December 14, 2020

Product Change Notice - Improved motor for PSX1 and PSX2 Power Stabilizing System

Fig.1 PSX1

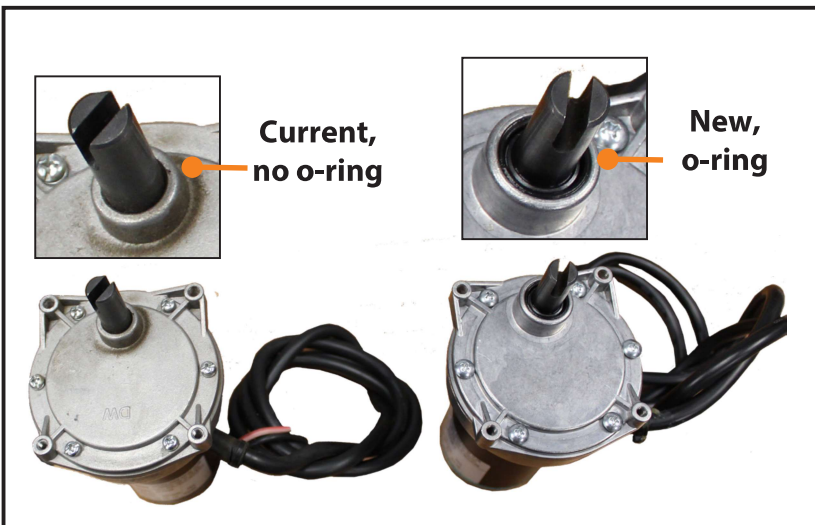
There is no change in fit, form or function with the improvement. The system comes from LCI with the motor installed on the stabilizer, so there is no change in installation for the OEM customer. The only change is for service on **PSX1 only** when switching out a current motor on a current system with a new motor. The hole in the motor bracket on a current system must be bored out at the bottom (Fig. 2) to accommodate the larger casting around the o-ring/shaft.
